COUNTY OF MIDDLESEX - INTERROGATORY #1

Filed: May 23, 2013
EB-2013-0040 and EB-2013-0041
Exhibit B
Tab 1
Schedule 3
Responses to County of
Middlesex Interrogatories
Appendix A

APPENDIX 'A'

Filed: May 23, 2013
EB-2013-0040 and EB-2013-0041
Exhibit B
Tab 1
Schedule 3
Responses to County of
Middlesex Interrogatories
Appendix B

PLS-CADD Drawing

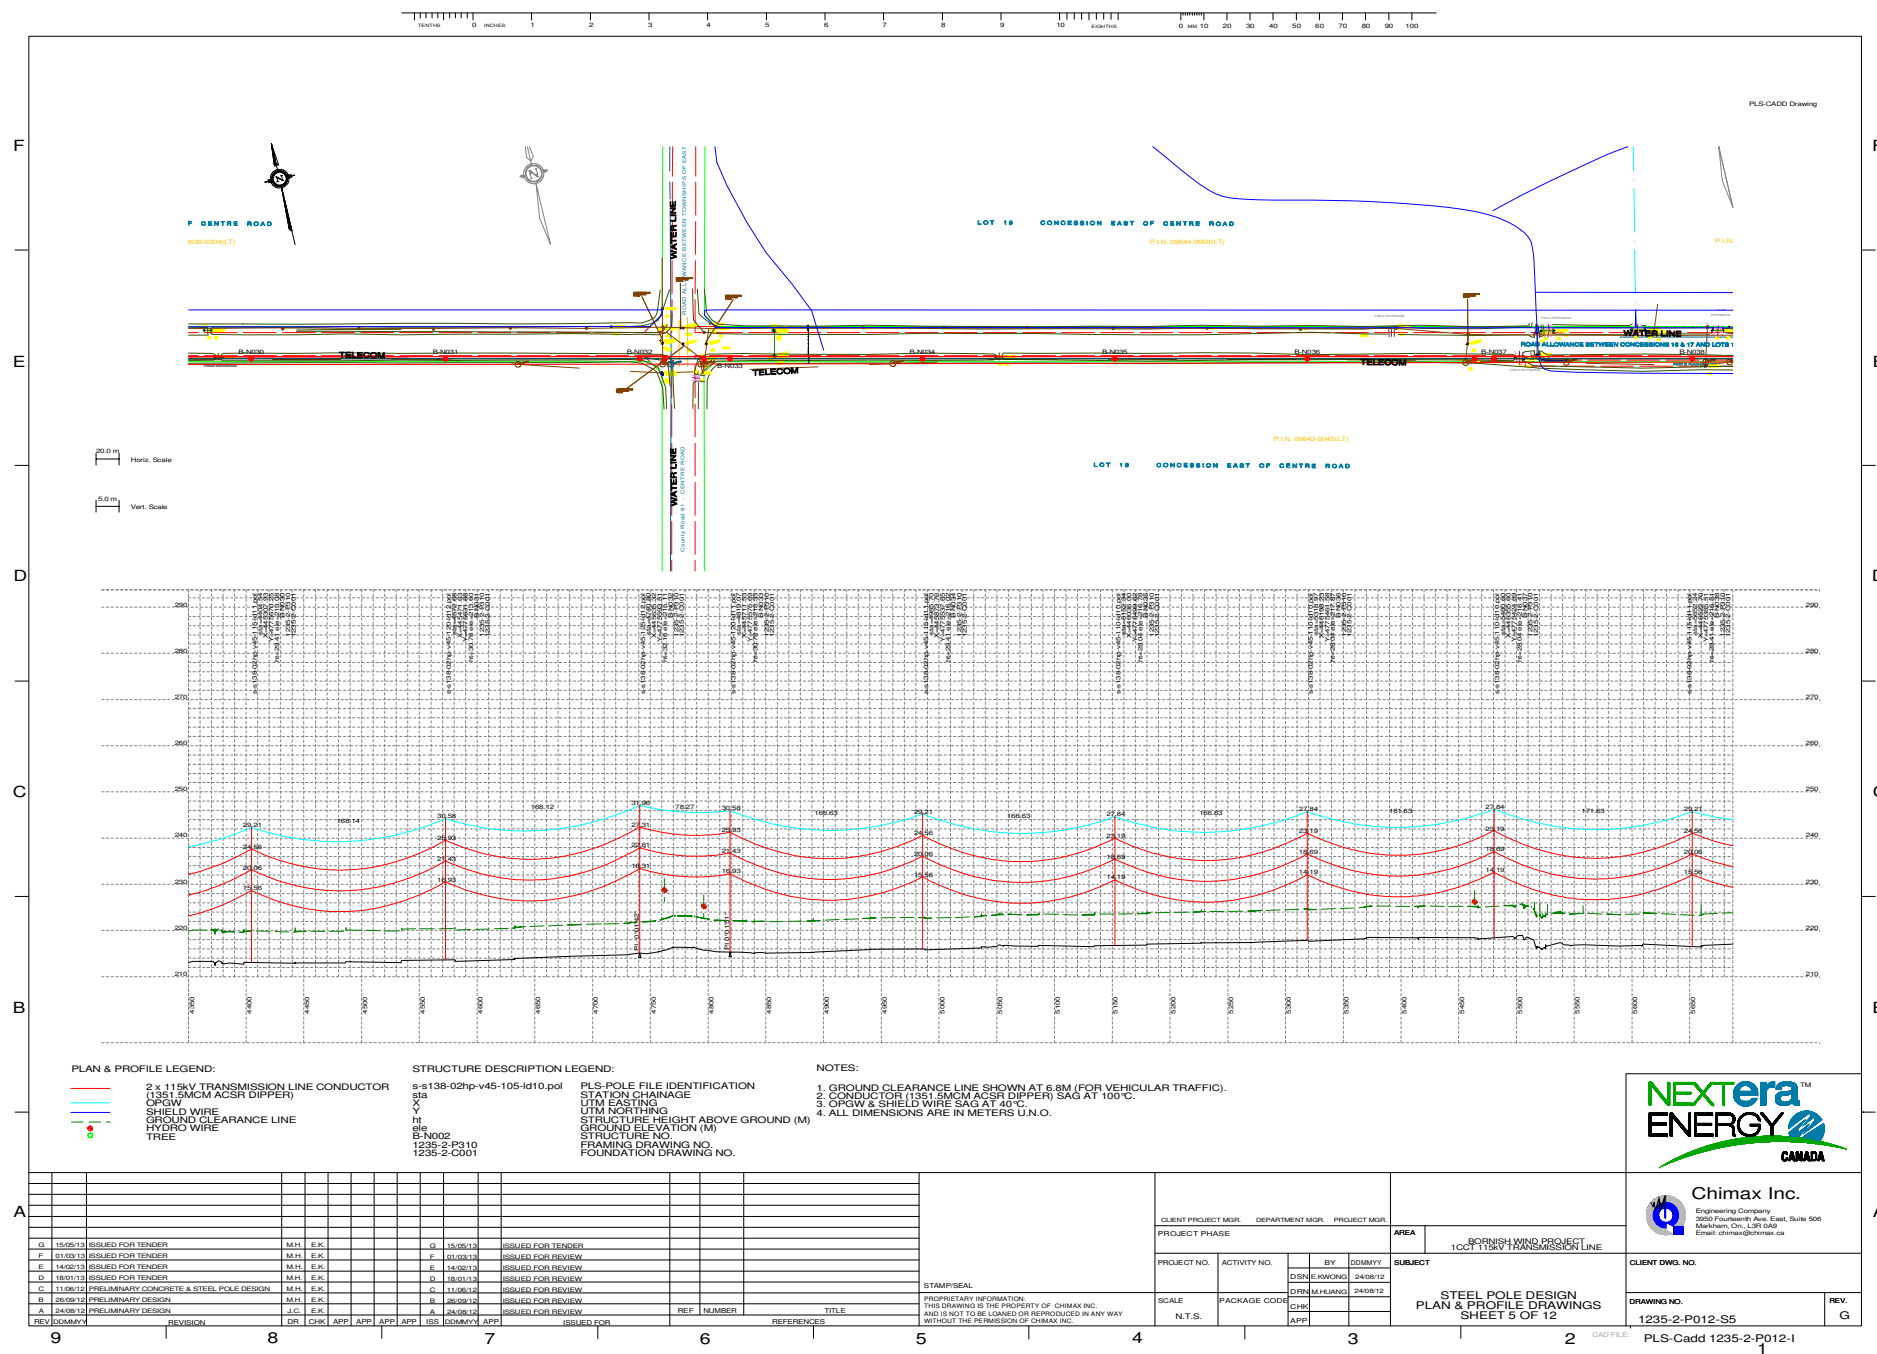
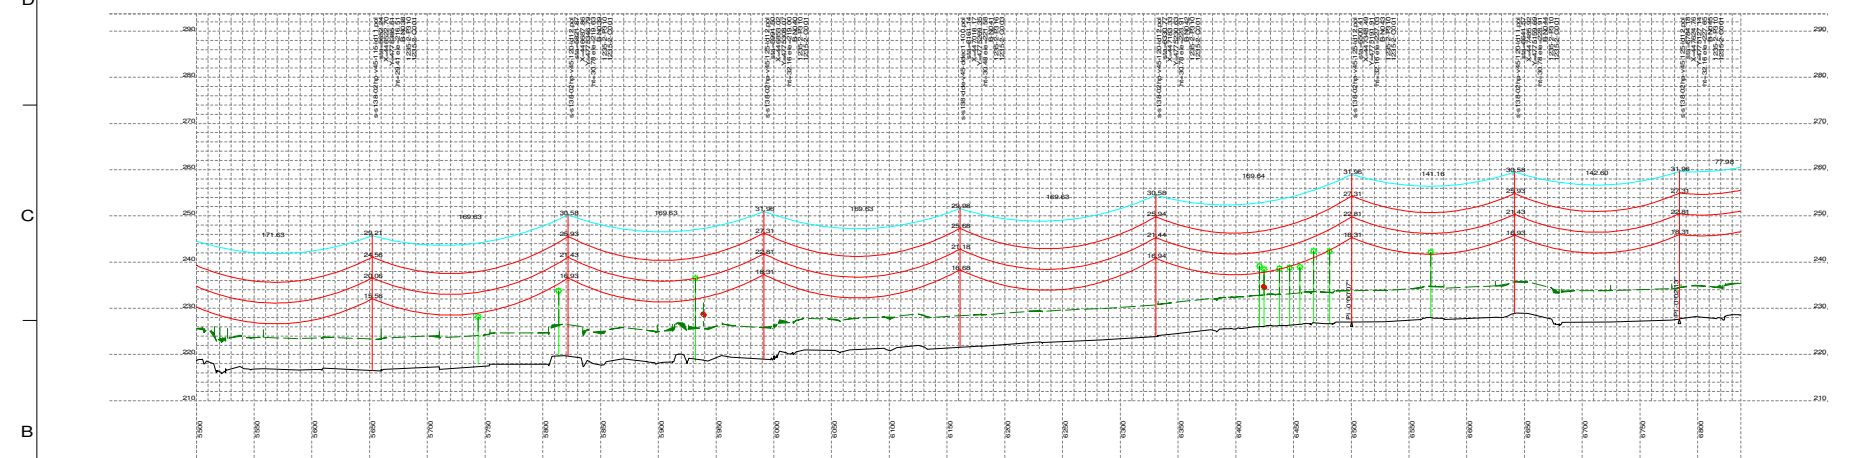
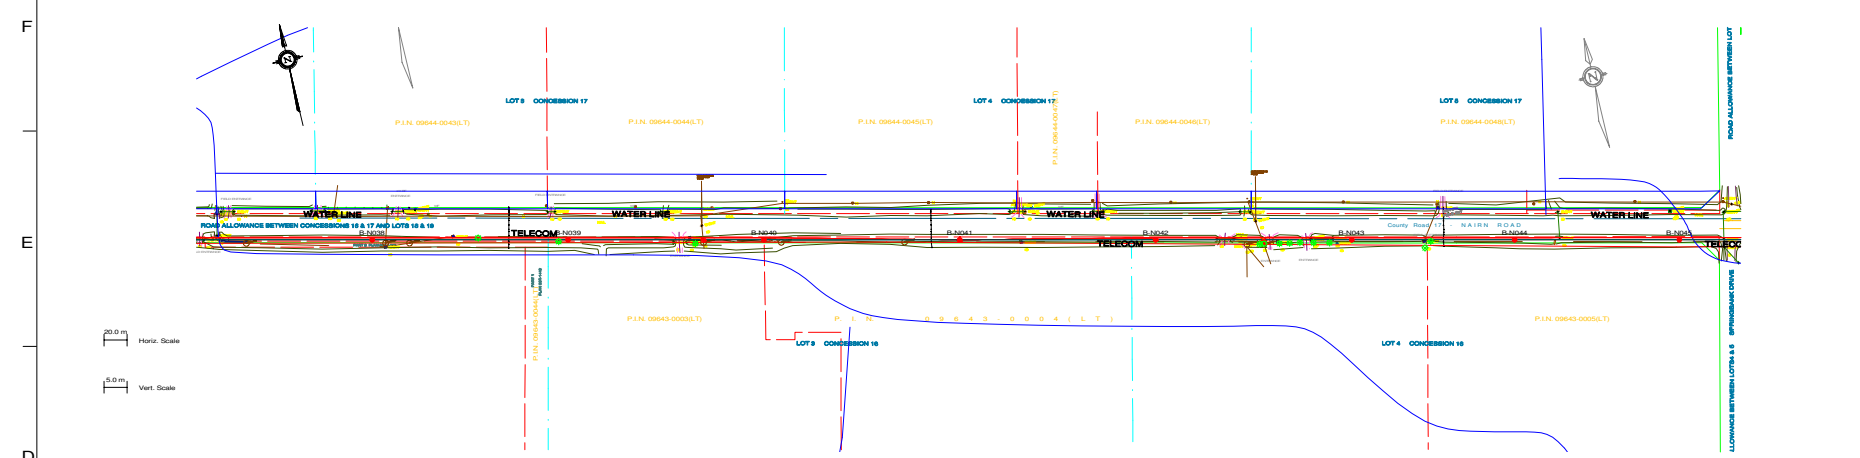
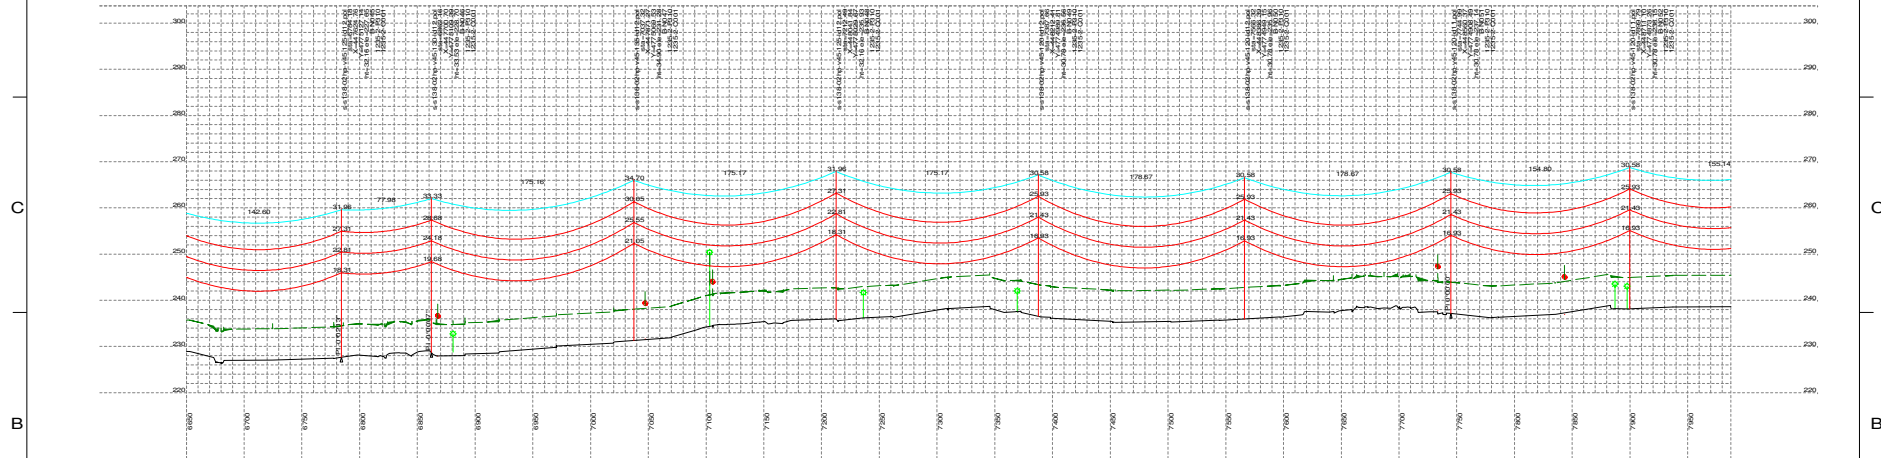
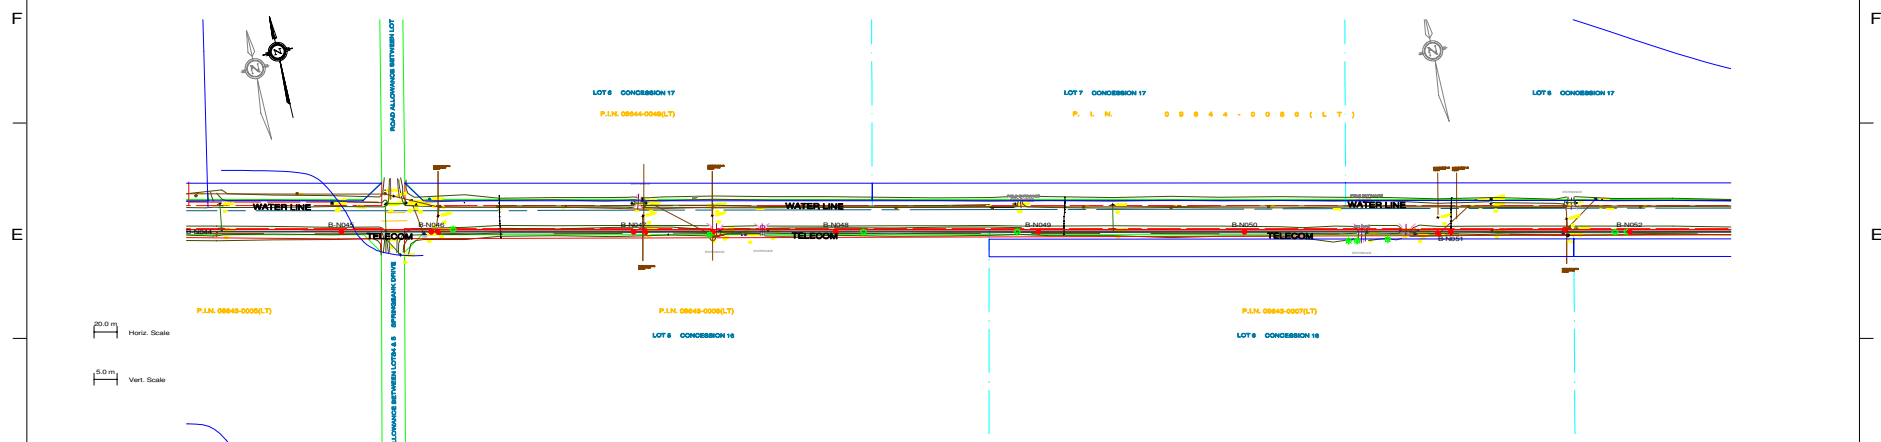
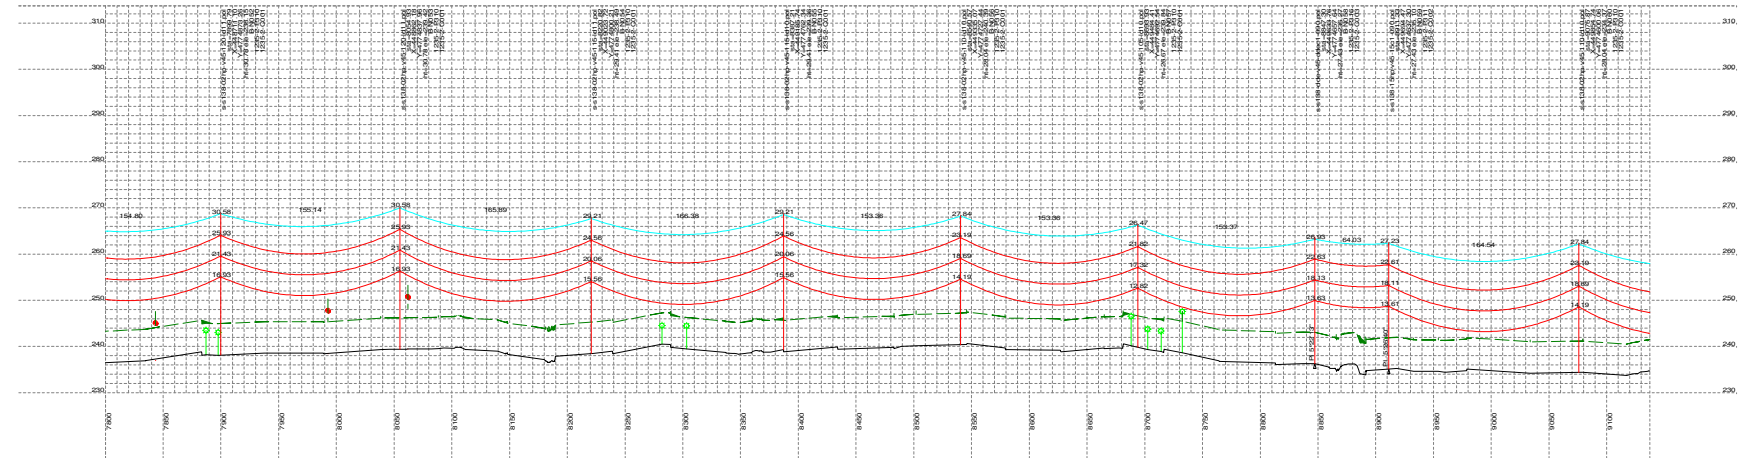
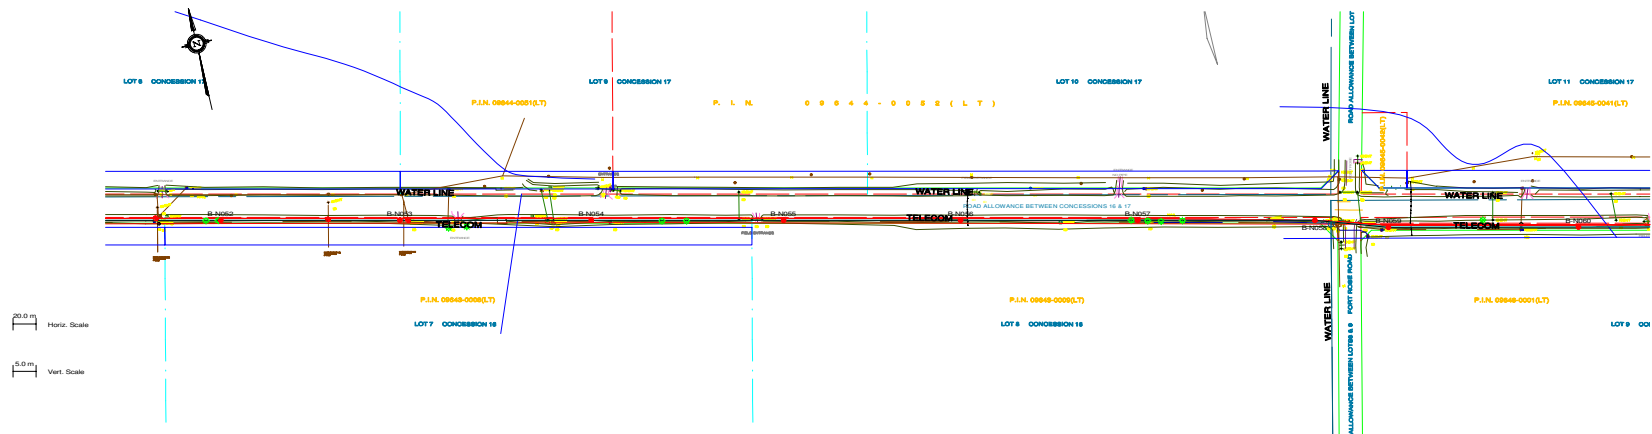
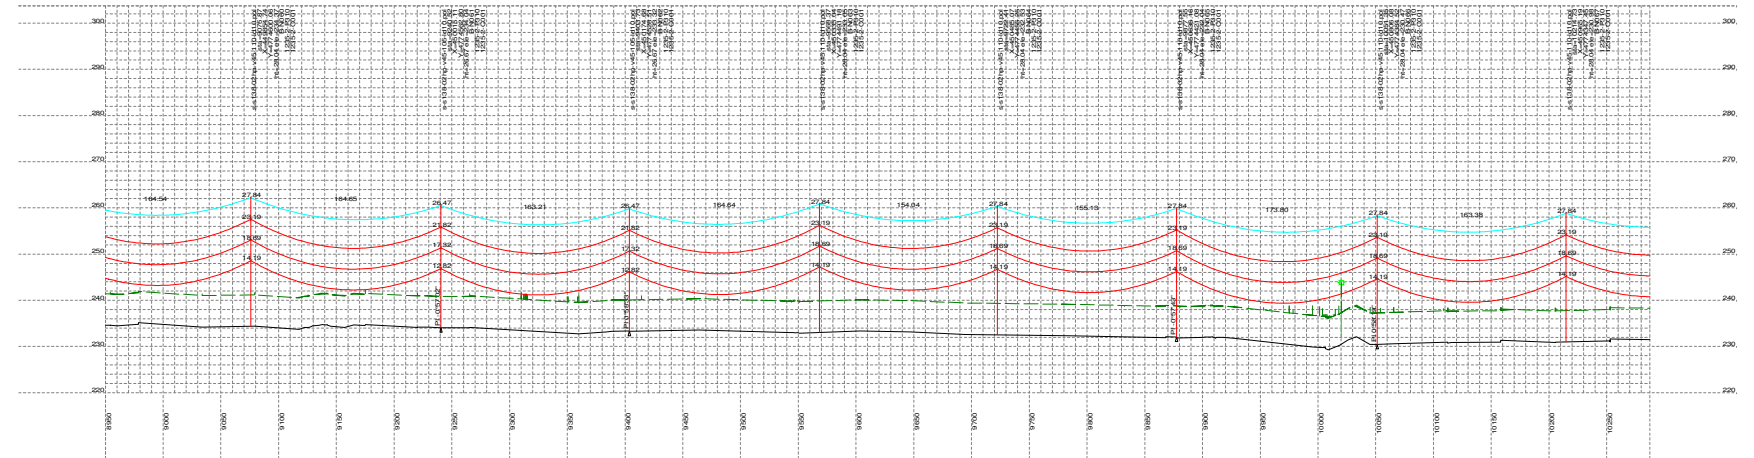
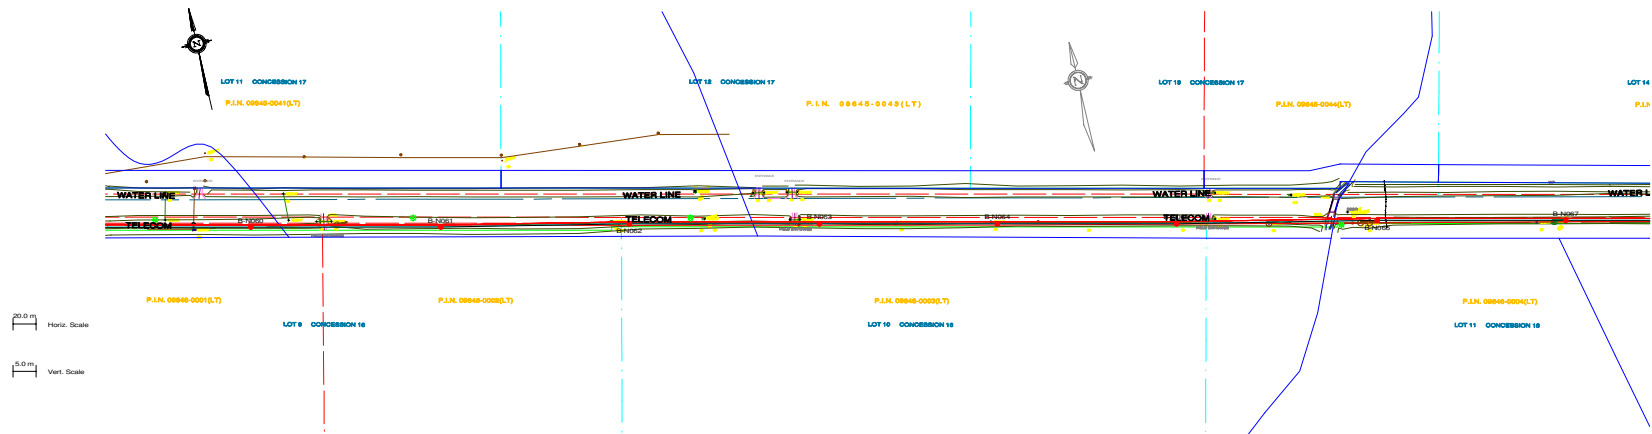
Please provide detailed engineering drawings showing the exact location of all poles and other appurtenances proposed to be located within County road allowances for transmission lines, including all material and construction specifications of poles, wires, guying, foundations, trenching, temporary conditions, and any other items related to this infrastructure.

Please see profile drawings in **Appendix 'A'** in respect of EB-2013-0040 and **Appendix 'B'** in respect of EB-2013-0041 depicting the current design, which is subject to final engineering. Earlier versions of these sets of drawings were provided to the County's Engineer on November 12, 2012. These drawings show the proposed pole, wire and anchor locations. Plans with respect to foundations, materials and construction specifications are not yet finalized. The physical design specifications for the proposed transmission line, including with respect to potential materials, are described in Exhibit D, Tab 1, Schedule 1. In addition, illustrations of potential pole structures and framing designs are provided in Figure 4 of Exhibit B, Tab 2, Schedule 5.
